Committee Date	31/3/22	
Address	85 Royston Road Penge London SE20 7QW	
Application Number	20/05254/FULL1	Officer - Susanna Stevenson
Ward	Penge And Cator	
Proposal	Construction of three storey residential building comprising six flats (1 no one bedroom, 3 no. two bedroom and 2 no. three bedroom) with associated cycle and car parking, refuse storage and landscaping.	
Applicant	Agent	
Neale	Mr Alex Richards	
Countrywide House 23 West Bar Banbury OX16 9SA	31-35 Kirby Street London EC1N 8TE	
Reason for referral to committee	Call-In	Councillor call in Yes

RECOMMENDATION	Permission
-----------------------	------------

Front elevation refused and dismissed at appeal 16/04224/FULL1

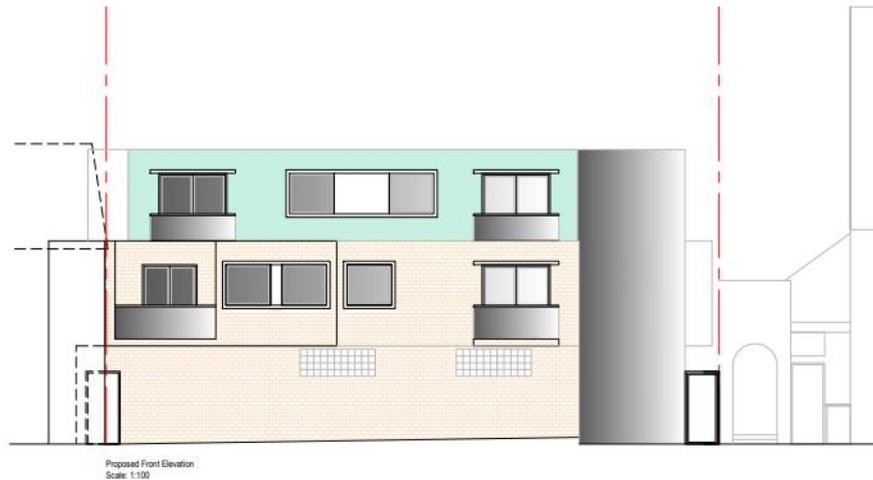
Planning permission was refused on the grounds:

1. The proposal, by reason of its height, bulk, design and siting, would result in a cramped overdevelopment of the site incongruous and out of character with the prevailing pattern of development in the locality and detrimental to the visual amenities and distinctiveness of the surrounding area, thereby contrary to Policies BE1 and H7 of the Unitary Development Plan, SPG1 and SPG2, Policies 3.5 and 7.4 of the London Plan, the Mayor of London's Housing SPG and the National Planning Policy Framework.

2. The proposal, by reason of its height, siting and design would have a significant detrimental impact on the residential amenities of the occupiers of neighbouring properties, resulting in a loss of privacy and visual impact, and would also fail to provide a satisfactory standard of accommodation for prospective occupants by way of private amenity space, thereby contrary to Policies BE1 and H7 of the Unitary Development Plan, adopted SPG1 and SPG2, Policies 3.5 and 7.4 of the London Plan, the London Housing Supplementary Planning Guidance and the National Planning Policy Framework.

Superseded front elevation

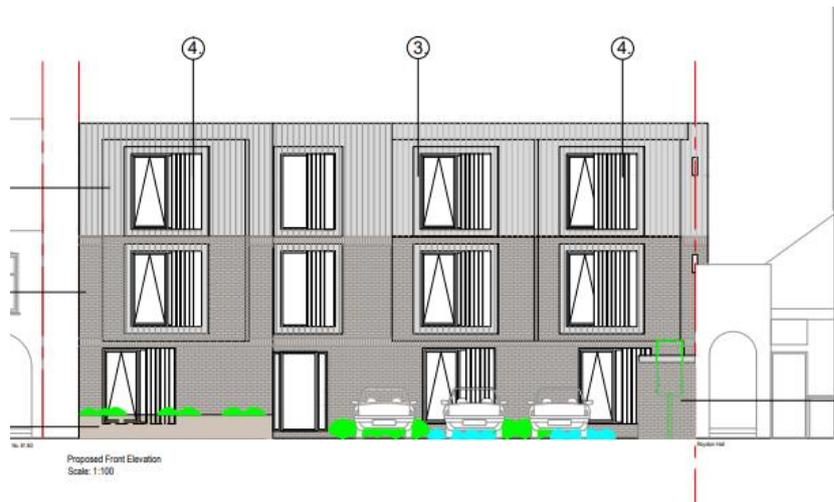
- 7.2.7 As originally submitted the scheme proposed a sheer front elevation with the use of contrasting materials, including grey brick, grey vertical zinc cladding and full height windows to each floor. The car parking spaces were positioned to one side of the building which also included cantilevered/staggered detailing to the front elevation. The building was also positioned with less space retained to the rear. The footprint of the development followed the geometry of the site and resulted in a convoluted building form with materials and detailing resulting in an imposing development.

Revised front elevation (8/12/21)

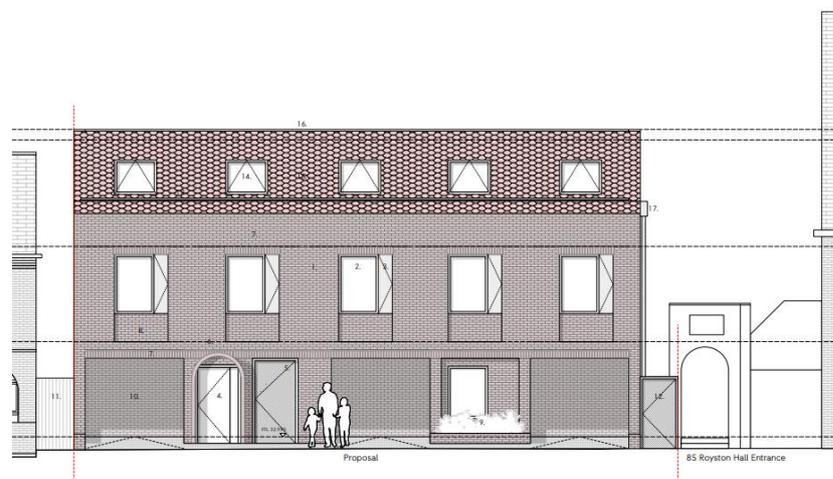
7.2.8 The application was subsequently amended, with the external appearance and layout of the building being made more consistent with the layout of the neighbouring dwellings in Royston Road (removing the staggered design elements at the front). The amended proposal incorporates a hipped roof feature which visually lessens the overall bulk of the development, and the materials and design detailing more readily complements the prevailing pattern and appearance of development in the locality.

7.2.9 While the proposal would still provide three floors of accommodation, the formation of the hipped roof element within the front elevation reduces the extent to which the building immediately presents as such, and the reduction in fenestration at second (top) floor level in conjunction with the hipped roof represents an improved design that more readily responds to local context.
